**BLOOMINGTON PLAN COMMISSION**  
**STAFF REPORT – First Hearing**  
**Location: 3615 East Post Road**

**CASE #: DP-17-24**  
**/ PLAT2024-04-0026**  
**DATE: July 15, 2024**

**REQUEST:** The petitioner is requesting primary plat approval to allow a two-lot subdivision of 4.21 acres in the Residential Medium Lot (R2) zoning district, with request for subdivision waivers and waiver of second hearing.

Summary of City of Bloomington Utilities Review of Proposed Plat #DP-17-24,  
PLAT2024-04-0026:

MYERS MINOR SUBDIVISION - PRIMARY PLAT  
A PART OF THE NORTHEAST QUARTER AND A PART OF THE  
SOUTHEAST QUARTER OF SECTION 35, TOWNSHIP 9 NORTH, RANGE 1  
WEST MONROE COUNTY, INDIANA

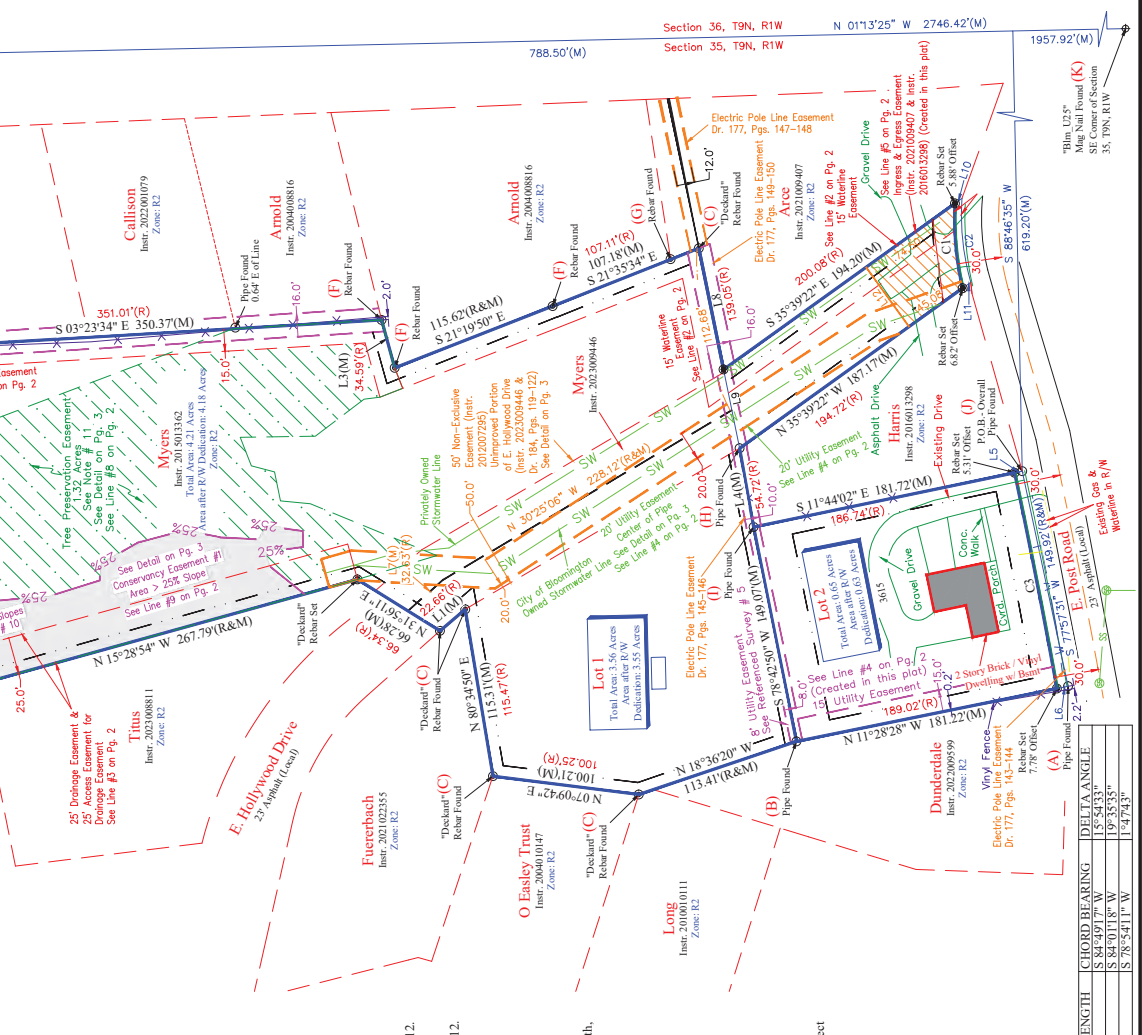
Drainage Calcs - The provided drainage calculations are not sufficient for CBU's review. The provided calculations included only the existing conditions of the watershed running through the proposed subdivision and up to the existing culvert north of the site.

Under the current CBU Stormwater Design Manual requirements, the drainage report must show that the pre-civilization peak runoff is equal to or less than the peak runoff of the post-developed site. Pre-civilization is defined as what the landscape would have been like prior to any human disturbance, generally, this is considered to be forest or prairie land, not what the conditions of the site looked like immediately prior to the proposed subdivision.

In this case, since there are no plans for development on the proposed parcels, the post-developed site conditions can be calculated by assuming the highest allowable amount of impervious surfaces (per zoning district defined in the UDO) will be built on the parcels.

Easements - The 25' access easement is not necessary over the 25' drainage easement. However, an access easement is needed to reach the drainage easement from the public right-of-way.

CBU asks to be named as a grantee on the access easement located on at the southern end of the unimproved portion of Hollywood Drive at Post Road.

The utility easement that is primarily located within the unimproved portion of Hollywood Drive should be exclusive to CBU.

Gabriel Holbrow has noted the conflict between the drainage easement and the conservancy easement. The resolution should be to adjust the conservancy easement so that the easements do not overlap. CBU must retain the right to construct drainage facilities.
